Summary of Comments on Sheet1

Edgewater Beach Resort
Phase 1
 Edgewater Drive
 20+00.00 - 24+49.74

Edgewater Beach Resort
Phase-1
Grading Plan

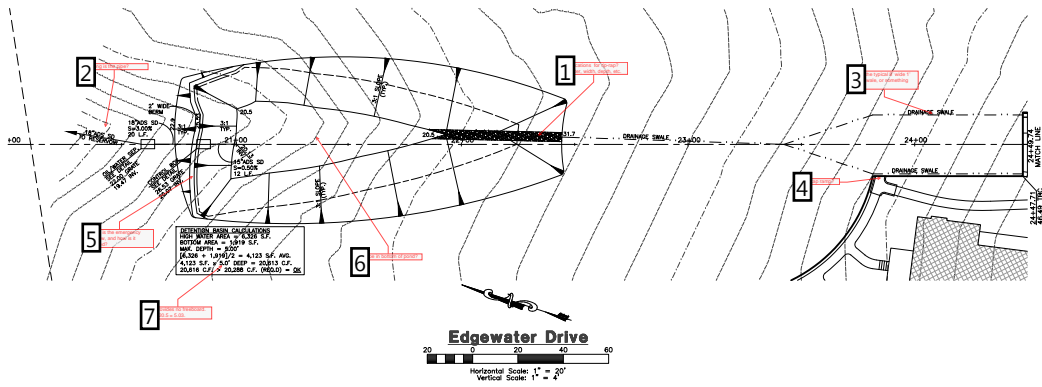
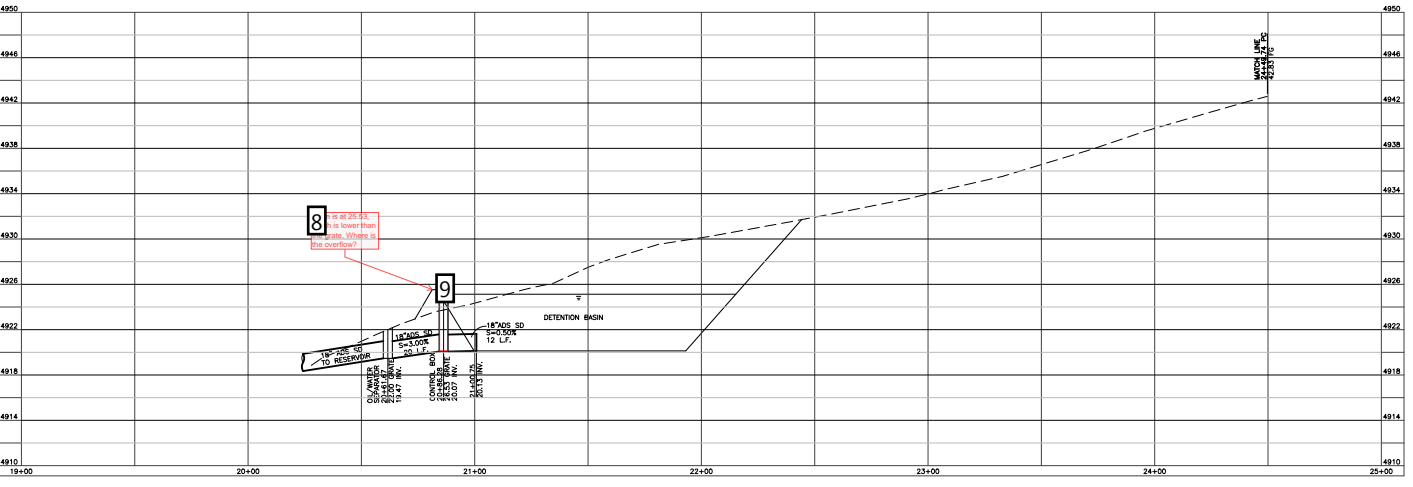
Number: 1 Author: mtuttle Subject: Callout Date: 8/20/2013 10:22:48 AM
Sign and date final drawings

Number: 2 Author: mtuttle Subject: Text Box Date: 9/4/2013 4:12:41 PM
Demolition information needs to be shown in the plans accounted for in the cost estimate.

Edgewater Beach Resort
 Phase 1
 Edgewater Drive
 24+497.4 - 30+00.00

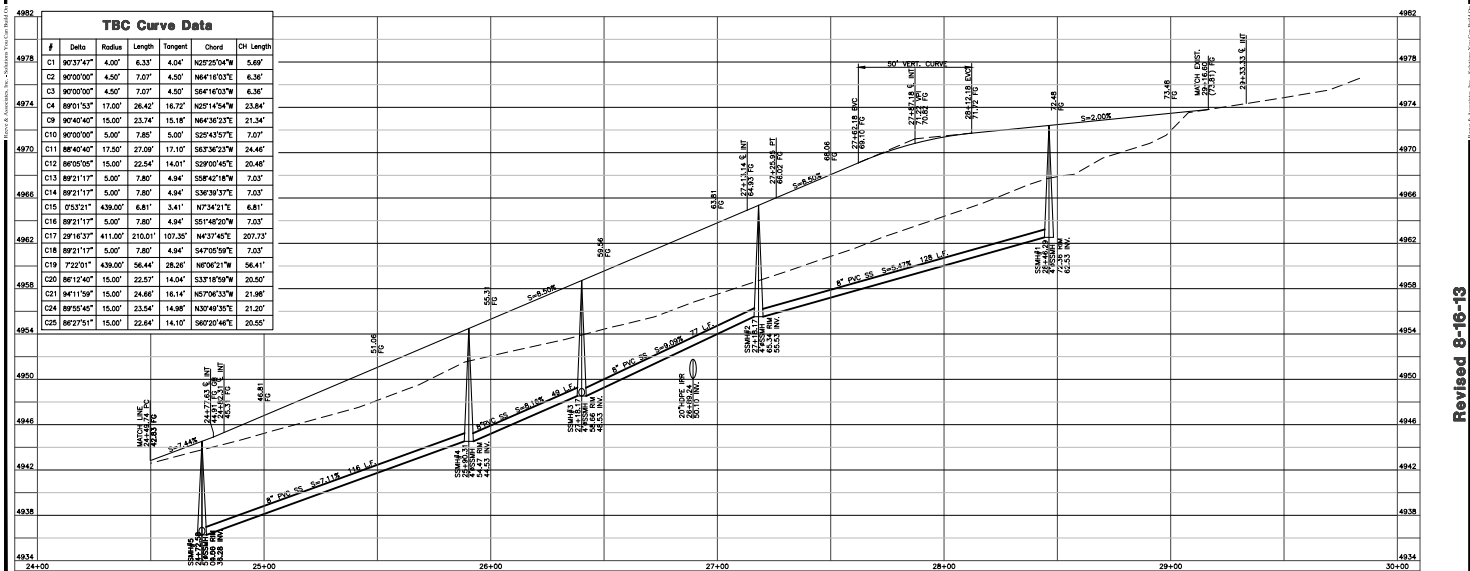
Number: 1	Author: mtuttle	Subject: Callout	Date: 9/4/2013 8:32:41 AM
	Specifications for rip-rap? Diameter, width, depth, etc.			
	Number: 2	Author: mtuttle	Subject: Callout	Date: 9/4/2013 9:04:12 AM
	How long is the pipe?			
	Number: 3	Author: mtuttle	Subject: Callout	Date: 9/4/2013 8:24:34 AM
	Is this the typical 8' wide 1' deep swale, or something else?			
	Number: 4	Author: mtuttle	Subject: Callout	Date: 9/4/2013 8:23:57 AM
	Handicap ramp?			
	Number: 5	Author: mtuttle	Subject: Callout	Date: 9/4/2013 9:07:38 AM
	Where is the emergency overflow, and how is it armored?			
	Number: 6	Author: mtuttle	Subject: Callout	Date: 9/4/2013 9:08:49 AM
	No slope in bottom of pond?			
	Number: 7	Author: mtuttle	Subject: Callout	Date: 9/4/2013 9:08:18 AM
	This provides no freeboard. $25.53 - 20.5 = 5.03$.			
	Number: 8	Author: mtuttle	Subject: Callout	Date: 8/19/2013 4:04:21 PM
	Berm is at 25.53, which is lower than the grate. Where is the overflow?

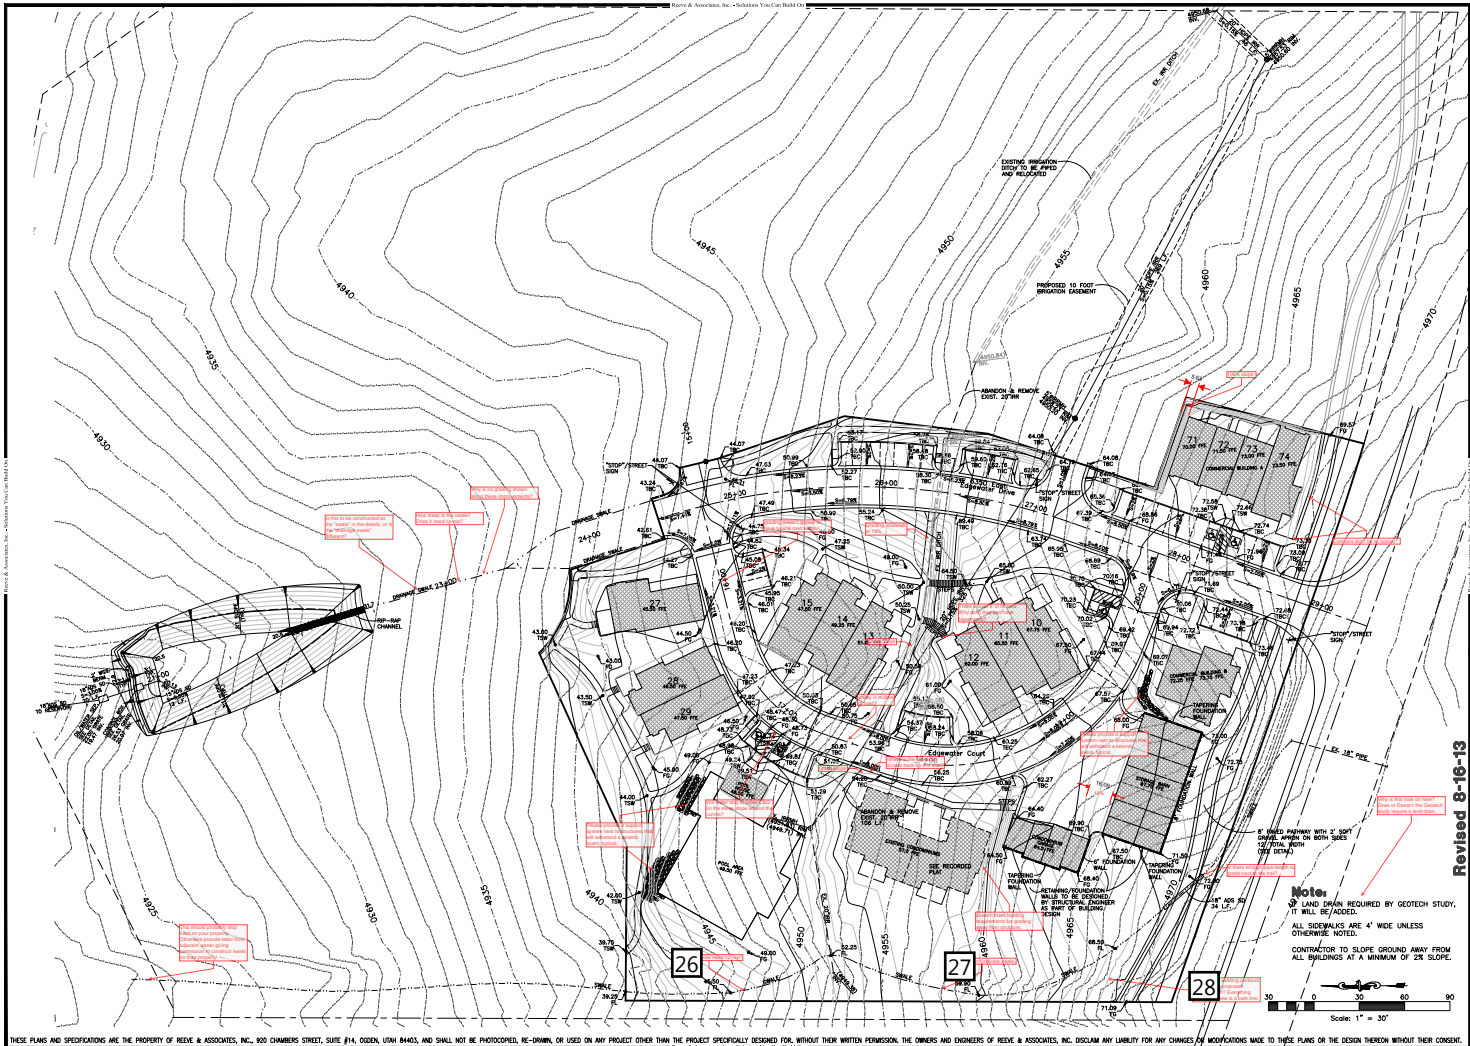
-
- ☰ Number: 1 Author: mtuttle Subject: Callout Date: 9/4/2013 8:11:11 AM
Stalls on this end have pretty steep slope.
-
- ☰ Number: 2 Author: mtuttle Subject: Callout Date: 9/4/2013 8:17:56 AM
Cross slope in stalls is 8.5% which may make it hard to open doors without slamming into the one down hill.
-

- ☰ Number: 3 Author: mtuttle Subject: Callout Date: 9/4/2013 9:59:02 AM
Where is the water going to go?
-
- ↗ Number: 4 Author: mtuttle Subject: Line Date: 9/4/2013 8:18:01 AM
-

3.28
-
- ☰ Number: 7 Author: mtuttle Subject: Callout Date: 9/4/2013 10:01:11 AM
What is this constructed of?
-
- ☰ Number: 8 Author: mtuttle Subject: Callout Date: 9/4/2013 8:22:02 AM
Where is this ramp directing people? There's no access, no sidewalk across Edgewater Drive.
-

- ☰ Number: 9 Author: mtuttle Subject: Callout Date: 9/4/2013 8:06:39 AM
Fix duplicate text, typical.
-
- ☰ Number: 10 Author: mtuttle Subject: Callout Date: 9/4/2013 8:28:20 AM
Will the water be maintained in the curb and gutter? Rolled Gutter is shown in the details. Please provide calcs showing inlet boxes are not needed.
-

- ☰ Number: 11 Author: mtuttle Subject: Callout Date: 9/4/2013 8:29:06 AM
Will water make this corner with the rolled gutter?

Please fix duplicate label, typical all locations.

How is these drive accesses going to work with 9% cross slope on driveway? One edge will be flat, and the other will have an 18% grade.

Should there be matching ramps across the streets, typical?

Number: 1 5.63	Author: mtuttle	Subject: Distance Measurement	Date: 9/4/2013 9:17:25 AM
Number: 2 106% slope	Author: mtuttle	Subject: Callout	Date: 9/4/2013 9:21:31 AM
Number: 3 Why is no grading shown along these improvements?	Author: mtuttle	Subject: Callout	Date: 9/4/2013 8:33:45 AM
Number: 4 How steep is the swale? Does it need rip-rap?	Author: mtuttle	Subject: Callout	Date: 9/4/2013 8:34:16 AM
Number: 5 Is this to be constructed as the "swale" in the details, or is the "drainage swale" different?	Author: mtuttle	Subject: Callout	Date: 9/4/2013 10:07:15 AM
Number: 6 grading doesn't appear to have typical road section.	Author: mtuttle	Subject: Callout	Date: 9/4/2013 9:11:15 AM
Number: 7 Grading, sidewalk at 18%	Author: mtuttle	Subject: Callout	Date: 9/4/2013 9:13:13 AM
Number: 8	Author: mtuttle	Subject: Line	Date: 9/4/2013 9:16:55 AM
Number: 9 Contours don't tie in, typical.	Author: mtuttle	Subject: Callout	Date: 9/4/2013 9:17:02 AM

Number: 10 There is over 8' of fill here. Why don't they just have basements?	Author: mtuttle	Subject: Callout	Date: 9/4/2013 9:24:33 AM
Number: 11 Cross Slope	Author: mtuttle	Subject: Callout	Date: 8/29/2013 9:27:02 AM
Number: 12 Valley in middle of road?	Author: mtuttle	Subject: Callout	Date: 8/29/2013 9:31:30 AM
Number: 13 Please provide a support system next to structures that will withstand a seismic event, typical.	Author: mtuttle	Subject: Callout	Date: 8/29/2013 9:38:15 AM
Number: 14 Where is the handicap access back up this side?	Author: mtuttle	Subject: Callout	Date: 8/29/2013 9:25:54 AM
Number: 15 Cross Slope	Author: mtuttle	Subject: Callout	Date: 8/29/2013 9:25:24 AM
Number: 16 16.09	Author: mtuttle	Subject: Distance Measurement	Date: 8/29/2013 9:21:53 AM
Number: 17 12%	Author: mtuttle	Subject: Text Box	Date: 8/29/2013 9:20:43 AM
Number: 18 Why is this note on here? Does or Doesn't the Geotech study require a land drain.	Author: mtuttle	Subject: Callout	Date: 8/28/2013 3:44:43 PM

Number: 19 Will water stay in rolled C&G on the steep slope around the curves?	Author: mtuttle	Subject: Callout	Date: 9/4/2013 9:45:27 AM
Number: 20	Author: mtuttle	Subject: Typewritten Text	Date: 8/29/2013 8:56:27 AM
Number: 21 Please provide a support system next to structures that will withstand a seismic event, typical.	Author: mtuttle	Subject: Callout	Date: 8/29/2013 9:36:57 AM
Number: 22	Author: mtuttle	Subject: Line	Date: 8/29/2013 9:37:52 AM
Number: 23 Is there enough pipe length to grade next to the trail?	Author: mtuttle	Subject: Callout	Date: 8/29/2013 9:22:10 AM
Number: 24 Doesn't meet building requirements for grading away from structure.	Author: mtuttle	Subject: Callout	Date: 9/4/2013 9:43:14 AM
Number: 25 This should probably stop back on your property. Otherwise provide letter from adjacent owner giving permission to construct swale on their property.	Author: mtuttle	Subject: Callout	Date: 9/4/2013 11:05:54 AM

**Edgewater Beach Resort
 Phase-1
 Utility Plan**

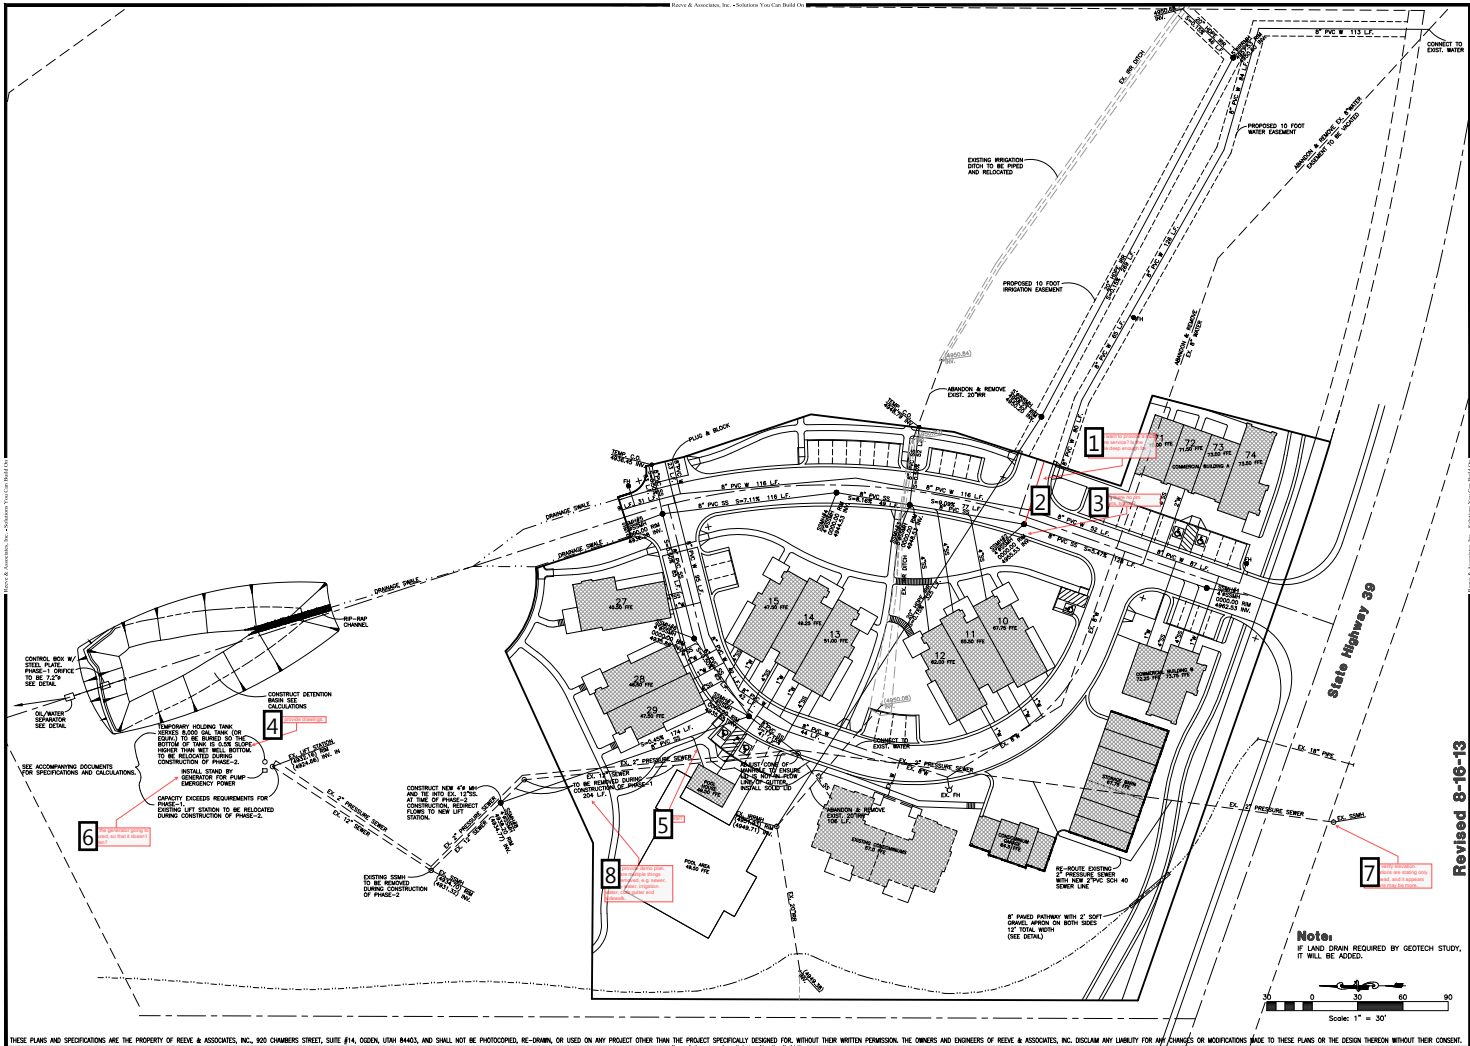
Does this swale need rip-rap?

Contours don't indicate swale.

Why are the existing contours dark and the proposed contours light? Everything else that is new is a bark line.

☰	Number: 1	Author: mtuttle	Subject: Callout	Date: 9/4/2013 8:57:05 AM
	Do you want to provide a stub for future service? Is the manhole deep enough for that?			
✓	Number: 2	Author: mtuttle	Subject: Line	Date: 9/4/2013 8:55:45 AM
☰	Number: 3	Author: mtuttle	Subject: Callout	Date: 9/4/2013 8:56:21 AM
	Why are there no rim elevations, typical?			
☰	Number: 4	Author: mtuttle	Subject: Callout	Date: 9/4/2013 3:51:26 PM
	Please provide drawings.			
☰	Number: 5	Author: mtuttle	Subject: Callout	Date: 9/4/2013 9:00:12 AM
	SS lateral?			
☰	Number: 6	Author: mtuttle	Subject: Callout	Date: 9/4/2013 10:12:03 AM
	How is the generator going to be secured, so that it doesn't get stolen?			
☰	Number: 7	Author: mtuttle	Subject: Callout	Date: 9/4/2013 10:17:05 AM
	Please verify elevation. Calculations are stating only 40' of head, and it appears that there may be more.			
☰	Number: 8	Author: mtuttle	Subject: Callout	Date: 9/4/2013 9:00:02 AM

Please provide demo plan. There are multiple things being removed, e.g. sewer, culinary water, irrigation water, curb gutter and sidewalk.

8'-10" WALL FRONT ELEVATION
SCALE: NONE

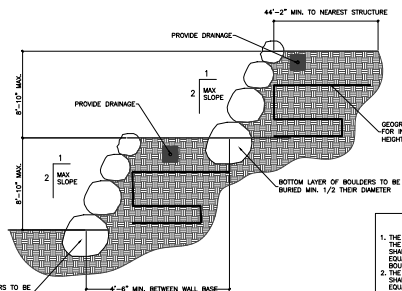
☰ Number: 1 Author: mtuttle Subject: Callout Date: 9/4/2013 11:25:41 AM
This is higher than the berm.

☰ Number: 2 Author: mtuttle Subject: Callout Date: 9/4/2013 11:25:59 AM
This would be about the height of the berm.

1. It shouldn't be near any trees, ponds, etc. Please provide suitable design for those situations.

**Edgewater Beach Resort
Phase-1
Storm Water Pollution
Prevention Plan Exhibit**

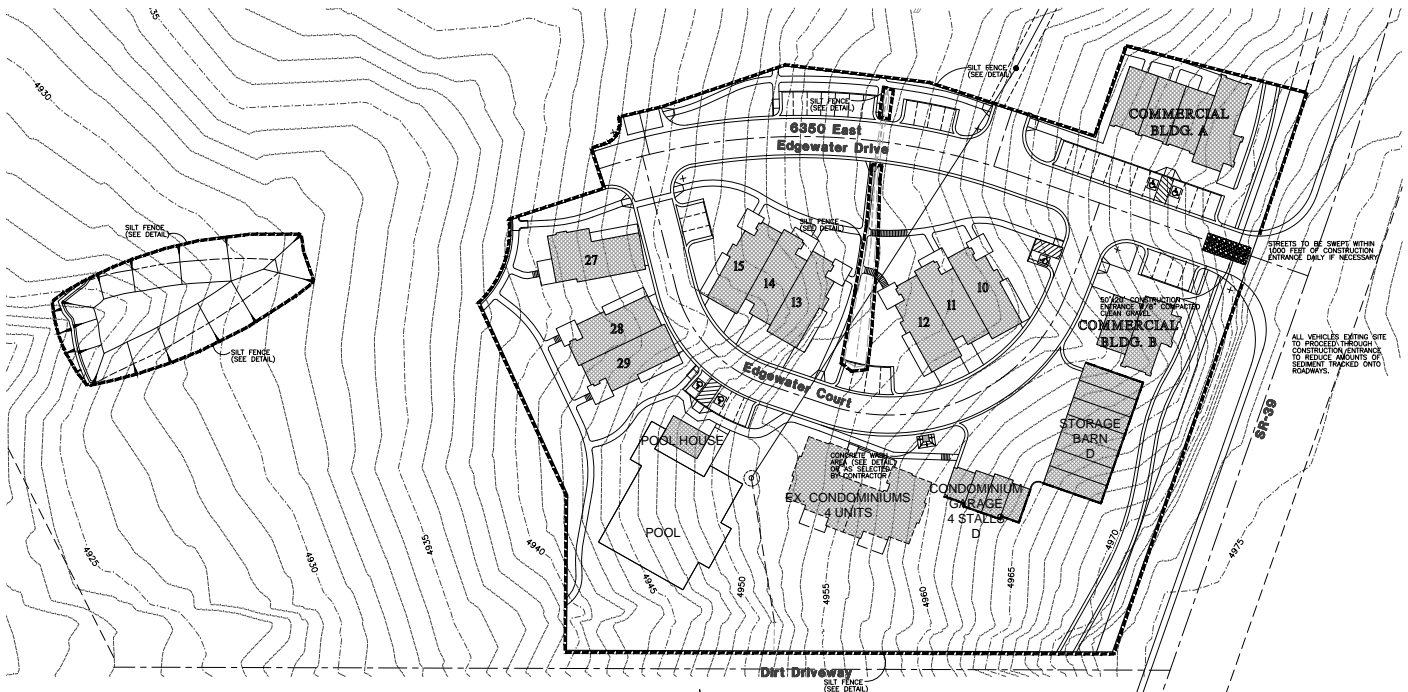
These shouldn't be used near any structures, pools, etc. Please provide suitable designs for those situations.

I haven't reviewed any of the SWPPP items since I haven't received the complete SWPPP packet yet. These last 2 pages could just be part of that document.
